**CHARLOTTE DOUGLAS INTERNATIONAL AIRPORT
CHARLOTTE, NORTH CAROLINA**

ADDENDUM NO. 1

**NORTH END AROUND TAXIWAY (NEAT)
OVERLOOK RELOCATION**

**CLT PROJECT NO. AVIA 23-50
ADDENDUM DATE: MAY 16, 2023**

DESIGNED BY: STV ENGINEERS	PROJECT ENG.: JNU
PROJECT NO.: 4020901837-5	DRAWN BY: KAM
CHECKED BY: MCG	DATE ISSUED: 05/15/2023

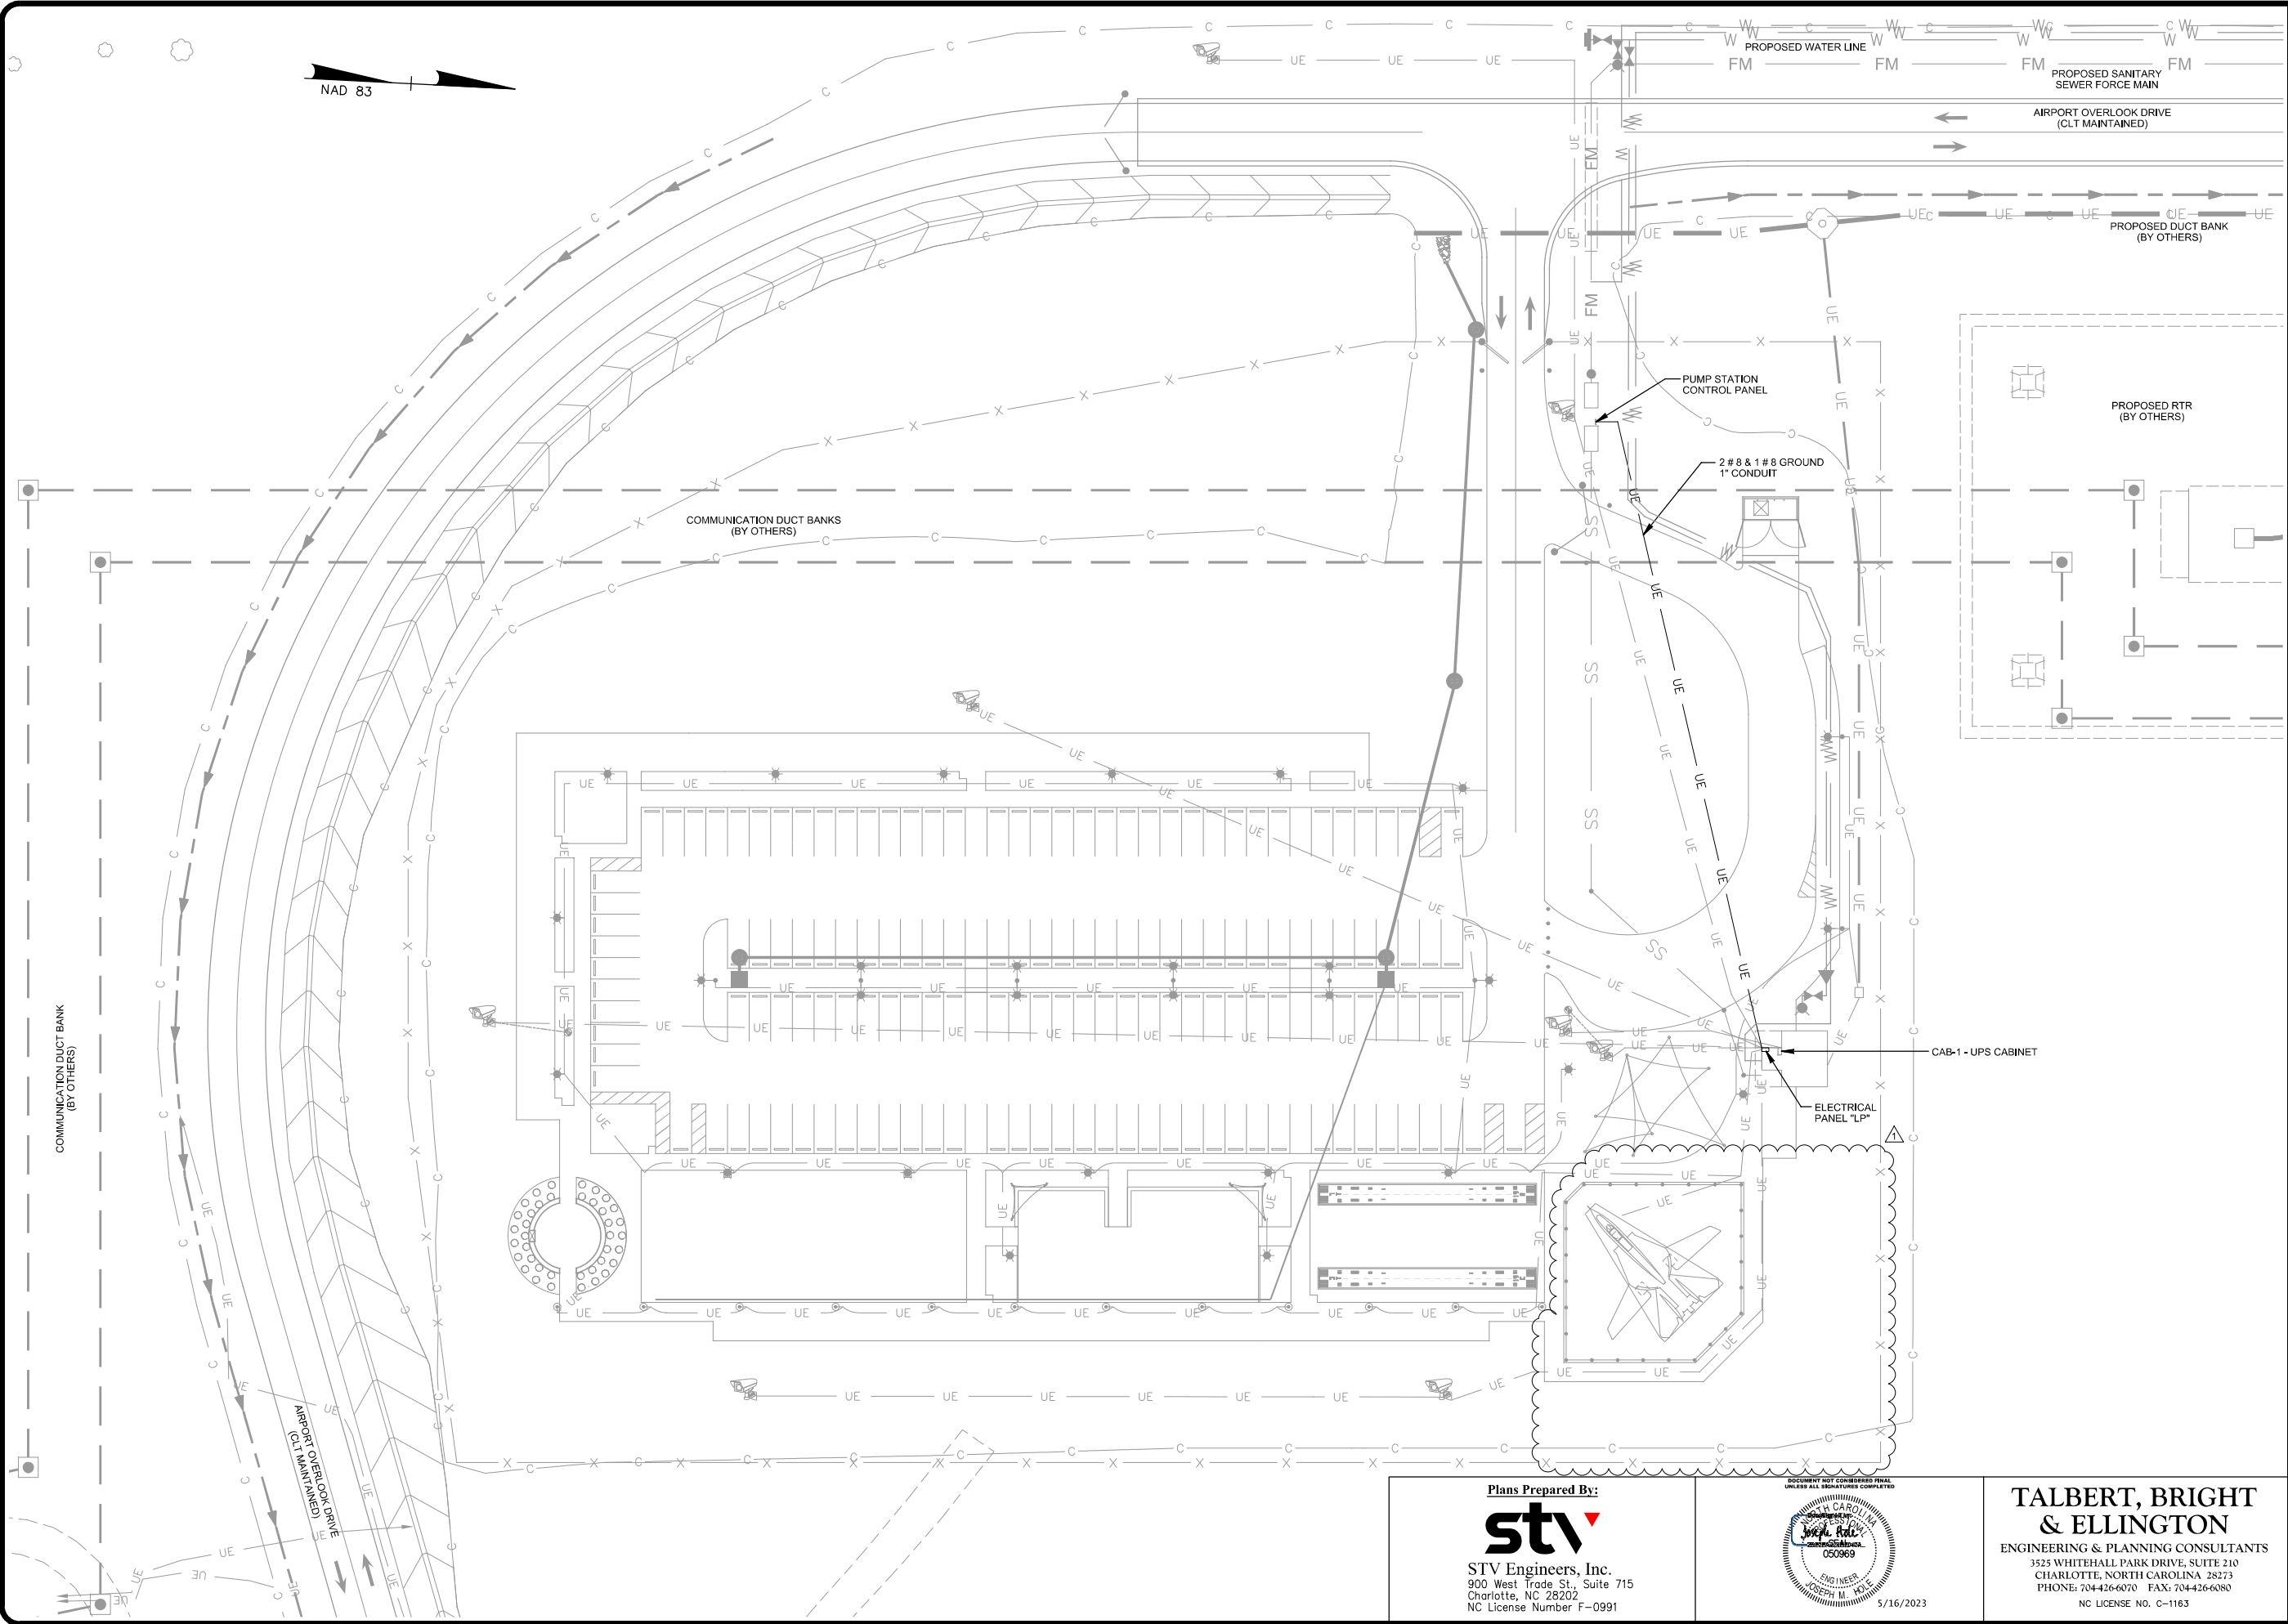
REVISIONS		DATE
1	ADDENDUM NO. 1 - REVISED AIRCRAFT DISPLAY AREA	05/15/2023
2		
3		
4		
5
